THE NEW SYDNEY FISH MARKET AT BLACKWATTLE BAY SSD 18_8924 and SSD 18_8925 MOD 1 RESPONSE TO SUBMISSIONS

Prepared for
Infrastructure NSW

February 2021

Figure 1: Relocation of rowing course (left – proposed, right – approved)

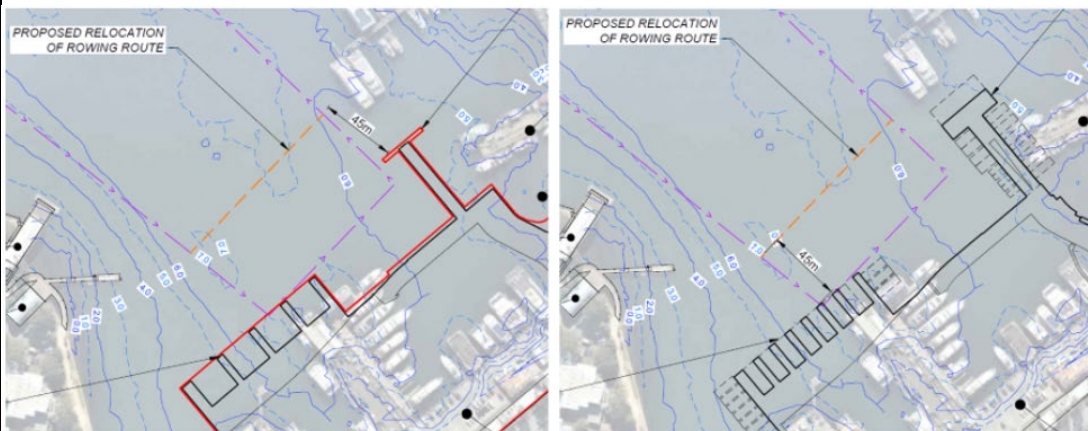
Department of Planning, Industry and Environment	Impact on Rowing Clubs	It appears the modification to the recreational wharf will result in shortening the length of the rowing route at the head of Blackwattle Bay when compared to the approved development (Figure 1). Further discussion on this aspect of the proposal shall be provided within the modification report including justification for the shortening of the rowing route and its potential impact on rowing clubs.	The rowing course was modified to be 45m clear of the new wharf position which was moved further west. The head of the proposed wharf is the site of a potential ferry wharf and would be subject to turning manoeuvres as the ferries move in and out of berth. As such, it is important that the rowing route is kept clear of this manoeuvring area. The basis of the original rowing route was that the route was kept 45m from wharves at the head of Blackwattle Bay (including the former Fish Market trawler wharves and Blackwattle Bay Marina). RHDHV have applied the same principal in determining the offset from the proposed wharves. The relocated rowing route has the effect of reducing the length of the rowing route by 60m on each side of Blackwattle Bay from its original length of c. 3100m. The previous revision showed a reduction of 48m on each side of the rowing route, a difference of 12m from approved SSDA route. This modification to the rowing course was issued to the rowing and dragon boat clubs. No concerns were raised.
